Urgent Field Safety Notice Update SynchroMed® II Programmable Pump

Update to Model 8870 Software Application Card used in the 8840 N'Vision™ Clinician Programmer and SynchroMed® Infusion System Labeling for Priming Bolus

December 2016

Medtronic reference: FA573 Phase II

New tubing volume value of **0.140 ml**, replaces previous value of 0.199 ml

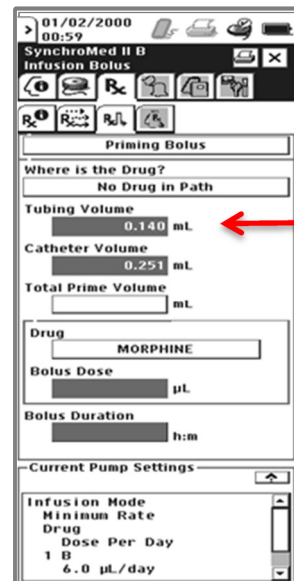
The software update will change the value displayed on the 8840 programmer for the SynchroMed II pump tubing volume from 0.199 ml to **0.140 ml** (see picture). The tubing volume is used to calculate the total volume of a full system priming bolus. This volume change does not alter the procedural steps or the other calculations required to program a priming bolus.
